UNITED STATES PATENT AND TRADEMARK OFFICE

APPLICATION NO.	FILING DATE	FIRST NAMED INVENTOR	ATTORNEY DOCKET NO.	CONFIRMATION NO.
10/782,206	02/18/2004	Ben M. Cooper	BO1 - 0137US	5282
60483	7590	04/17/2007		
LEE & HAYES, PLLC 421 W. RIVERSIDE AVE. SUITE 500 SPOKANE, WA 99201			EXAMINER LE, HUYEN D	
			ART UNIT	PAPER NUMBER
			3751	
SHORTENED STATUTORY PERIOD OF RESPONSE		MAIL DATE	DELIVERY MODE	
3 MONTHS		04/17/2007	PAPER

Office Action Summary

DETAILED ACTION

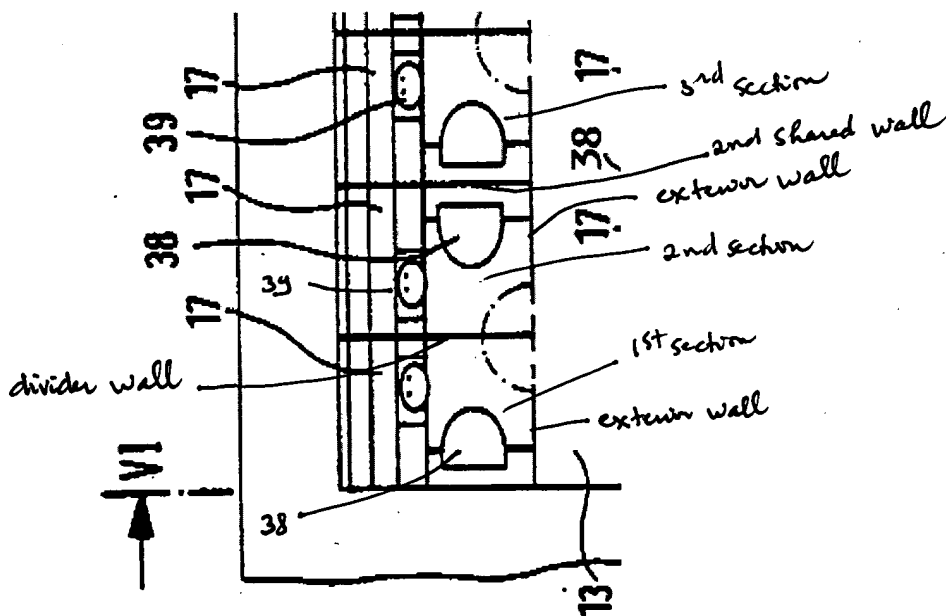
The Schwertfeger et al reference discloses lavatory unit (Fig. 5) comprising a floor 5 (Fig. 6); a ceiling 3 (Fig. 6); a plurality of exterior walls (see a section of Fig. 5 below) coupled to the floor 5 and the ceiling 3, at least two of the exterior walls (the interior side walls near the corridor or waiting area 13 shown in Figs. below) lying in intersecting planes; a first section including a sit-down commode 38 (the 1st toilet area from the bottom in a section of Fig. 5 below); a second section (adjacent to the 1st toilet area) including a sink 39; and a divider wall (as labeled between two toilet areas in a section of Fig. 5 below) for separating the first and second sections, wherein the divider wall includes a planar divider, wherein the planar divider lies in a third plane intersecting both of the intersecting planes.

Regarding claim 2, the first section also includes a sink 39.

Regarding claim 5, a third section (the 3rd toilet area from the bottom of a section of Fig. 5 above) that shares a first shared wall (the ceiling wall 3 in Fig. 6) with a first

section and a second shared wall (the dividing wall between the 2nd toilet area and the 3rd toilet area) with the second section, wherein the third section (the 3rd toilet area) is accessible from the outside of the first section and the second section.

Regarding claim 7, the third section includes a trash compartment 17.

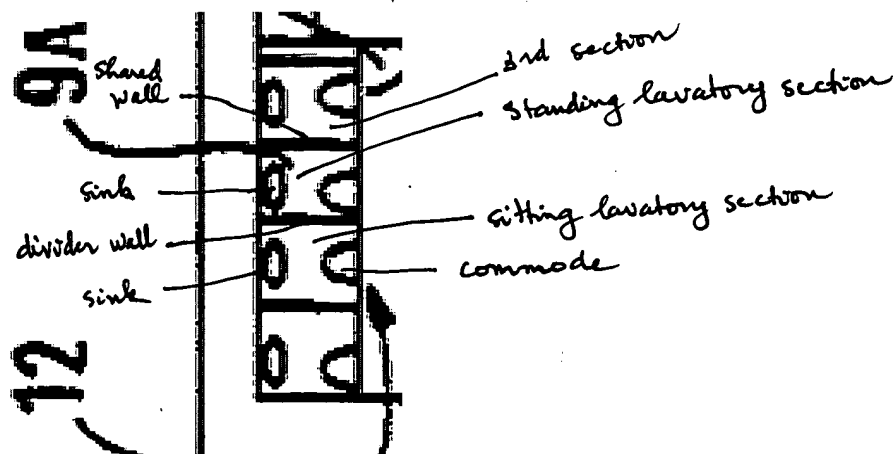
Regarding claim 25, the Schwertfeger et al reference discloses an aircraft (Fig. 2) comprising a fuselage 1, a propulsion system inherently included, a plurality of exterior walls separating the sections of the lavatory unit from other portions of the aircraft (see a section of Fig. 2 below), the plurality of walls defining a footprint of the lavatory unit, a sitting lavatory section including a sit-down commode and partially occupying the footprint (as labeled in a section of Fig. 2 below); and standing lavatory section including at least a sink (as labeled in a section of Fig. 2 below); an adjoining divider wall configured to separate the lavatory unit into the sitting and standing lavatory sections, the divider disposed such that the standing lavatory section (as labeled below) occupies a minority portion of the footprint and the standing lavatory section inaccessible from the sitting lavatory section.

Regarding claim 26, the sitting lavatory section also includes a sink (shown as an oval in Fig. 2).

Regarding claim 29, a third section (as labeled in a section of Fig. 2 above) that shares a wall (the ceiling wall 3 in Fig. 6) with a the sitting lavatory section and a wall (the dividing wall between) with the standing lavatory section, wherein the third section is accessible from the outside of the sitting lavatory section and the standing lavatory section.
